## Supplemental Information - Appeal of project 598124 - Federal Blvd. Marijuana Outlet

Tuesday, December 4, 2018

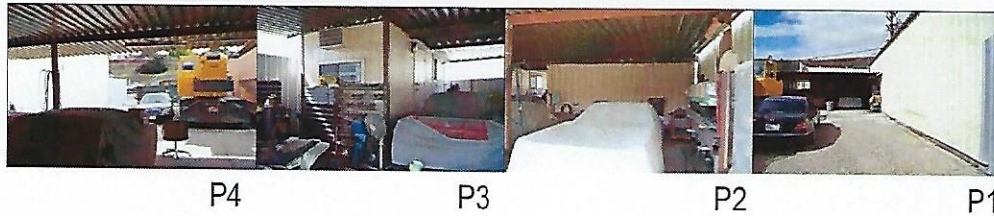
- iii. Year of original construction for permanent structures is Missing in project information on sheet CS, although a series of images were provided by the applicant which clearly depicted permanent structures, as defined by the California Building Code, located on the site. (*snapshots of actual drawings below*).

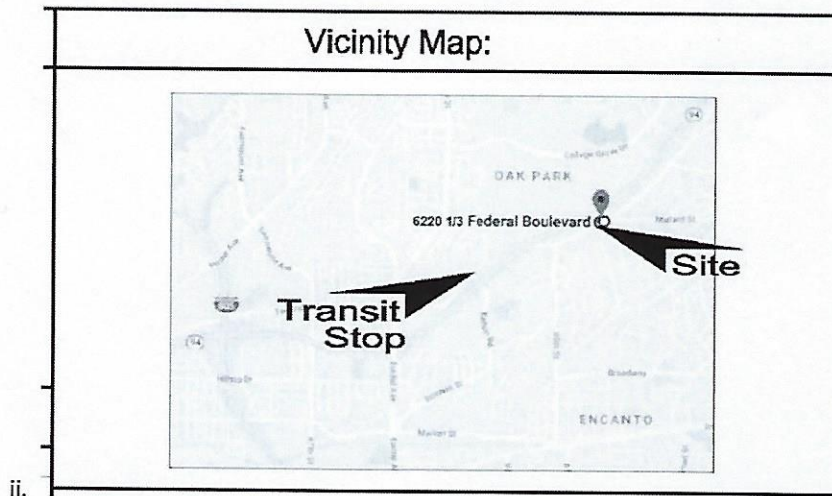
- i. Vicinity map is Missing north arrow and does not it comply with information Bulletin 122. (snapshots of actual drawing below).

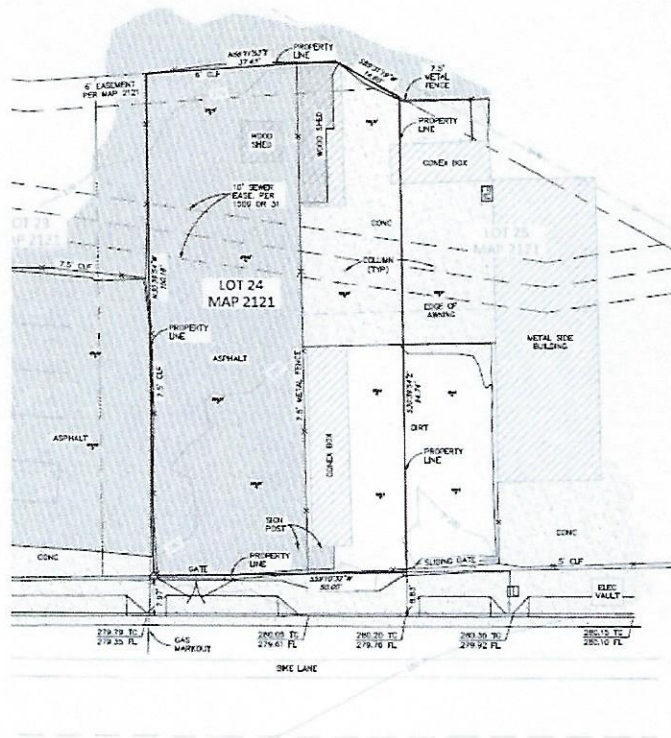
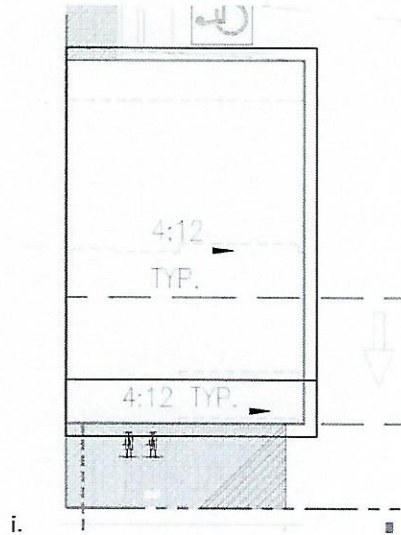
- i. Site plan on Sheet SP2 is Missing the required drainage pattern depiction.

- i. Site plan on sheet SP2 is Missing Site Section Lines depicting cross sections through the entire site in at least two directions.

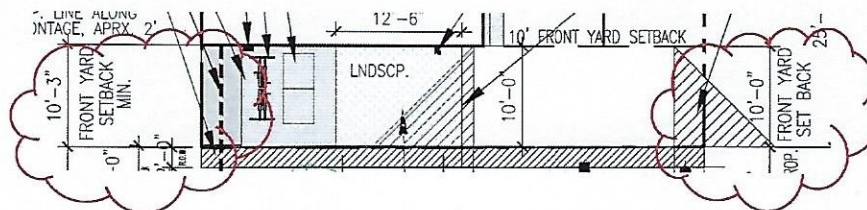
- 2.4. Phantom Floor Area completely unaccounted for in "Open to Below" space: (See Sheet A1.00)
  - 2.4.1. SDMC Section 113.0234 – Calculating GFA – Diagram 113-02P 4(A) *Phantom Floors*. When the vertical distance between the finish-floor elevation and the finish-floor or flat roof immediately above does not exceed 15 feet, the area of one floor (the actual floor) is included in gross floor area, as shown in Diagram 113-02Q.

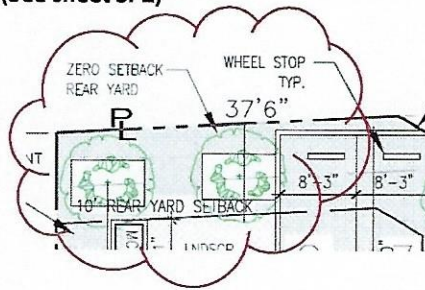
- 3.3. No setback information is provided on the proposed elevations (See sheet A5.00, A5.01)
- 3.4. No setback information is provided on the proposed sections (See sheet A6.00)
- 3.5. 7/24/2018 and 11/20/2018 plan sets (See sheet SP2) front setback is incorrectly shown as 10'-0" and 10'-3".

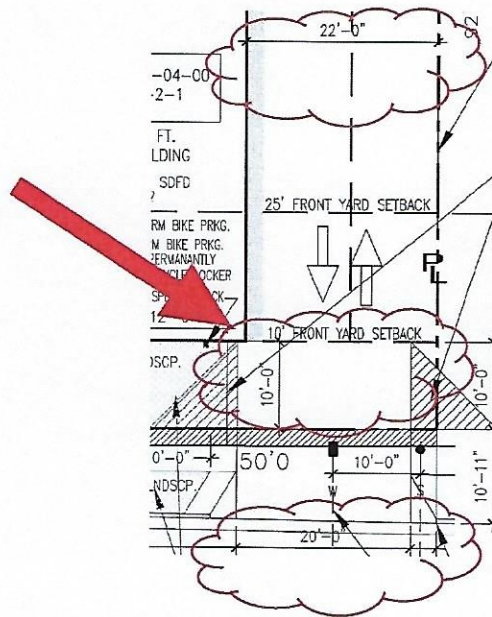
4.1. A 20' driveway curb opening width (with aprons 3' on both sides driveway) is proposed. As the driveway width interfaces with the drive aisle width of 22', the building becomes an obstacle that requires the driveway width to be reduced as it connects to the 22' drive aisle. (See sheet SP2). The project fails to provide the minimum 20' driveway since the building is an obstacle.

The proposed driveway design is not compliant. A corner of the building would have to be removed in order to provide for an appropriate transition.

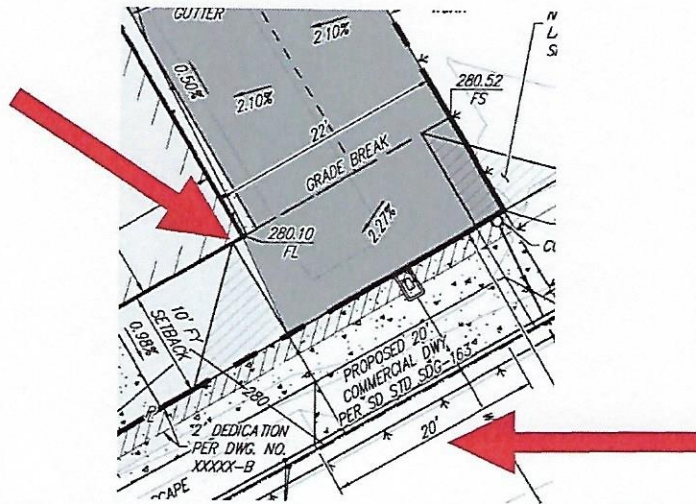
- 4.2. Sheet C.2 conflicts with sheet SP2. The dimension depicting the width of the driveway indicates a driveway located approximately 4' in front of the building. This drawing is both non-compliant and also not consistent with the other submitted site plans.

- 4.3. The driveway width is reduced and not correctly shown on the Site Plan (SP2), Roof Plan (A2.00) and Floor Plans (A1.00) angling inward and Landscape (L1, L2). The proposed driveway design, which is inconsistent with the other submitted drawings, also does not comply as it depicts a driveway that is both not parallel to the front property line and also does not maintain the minimum required width of 20'.
